STP NUCLEAR OPERATING COMPANY
Units 1 and 2
Docket Nos. STN 50-498; STN 50-499
Changes to Emergency Plan & Implementing Procedure

**Description of Changes
0ERP01-ZV-OF01**

Alternate Emergency Operations Facility Activation, Operation, and Deactivation, Rev. 2

BAY CITY SERVICE CENTER FLOOR PLAN

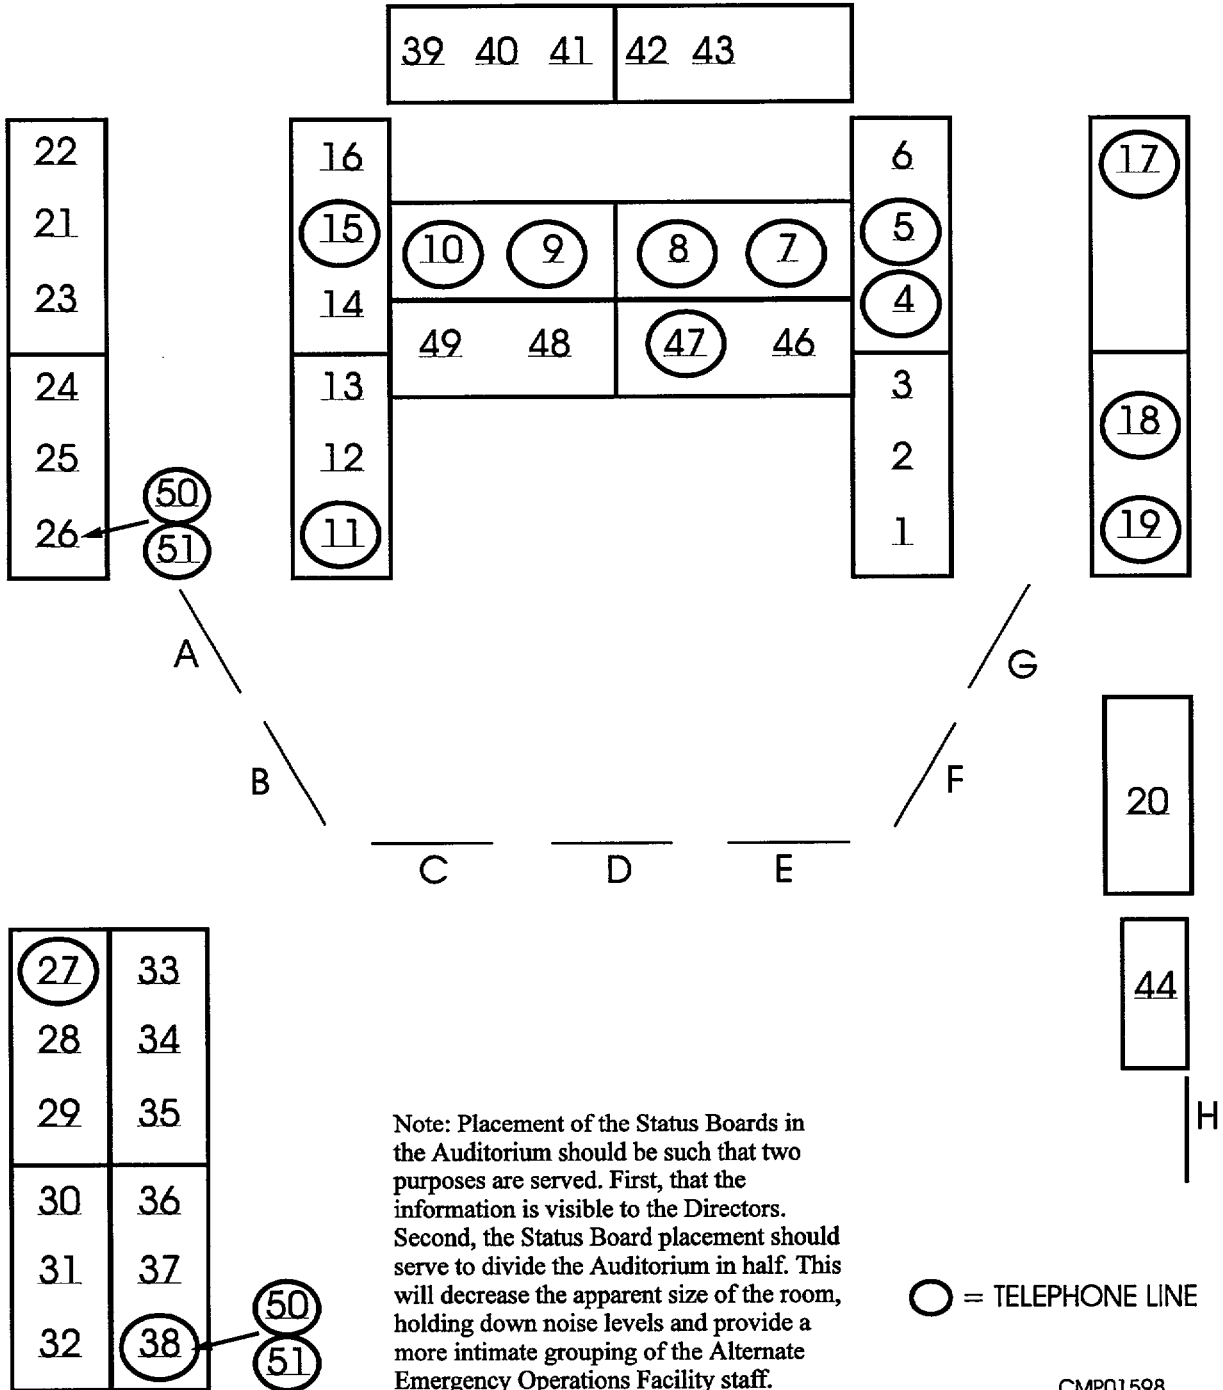
5.3.6 “Rad Van personnel shall establish contamination control and monitoring as necessary.”	“establish a frisking station as illustrated in Addendum 1” . . Additional instructions for location of frisking station.

Revision 1	Revision 2
Addendum 1, Page 11 #27 Telephone Operator	Position has undergone name and responsibility change. Now – Information System Analyst.
Addendum 1, Page 11 #30 Owners Liaison	Position has undergone name and responsibility change. Now – EOF Liaison
Addendum 1, Page 12 #s 32 and 36	Positions have been deleted. Seats are now open.
Form 1 #1, 2, and 3 Rad Van responsibilities	Responsibilities changed to Rad Staff. Rad Van personnel no longer on ERO.
Form 1 # 4 and 5 Communications System Technician responsibilities	Responsibilities changed to Communications System Supervisor

- 5.3.6 If possible, the Offsite Field Team Supervisor and Rad Staff 1 should retain control of the Offsite Field Teams during transit by utilizing the Rad Van as a mobile command post. Upon arrival at the Alternate Emergency Operations Facility, establish a frisking station as illustrated in Addendum 1, Alternate Emergency Operations Facility Equipment Layout and Floor Plan.
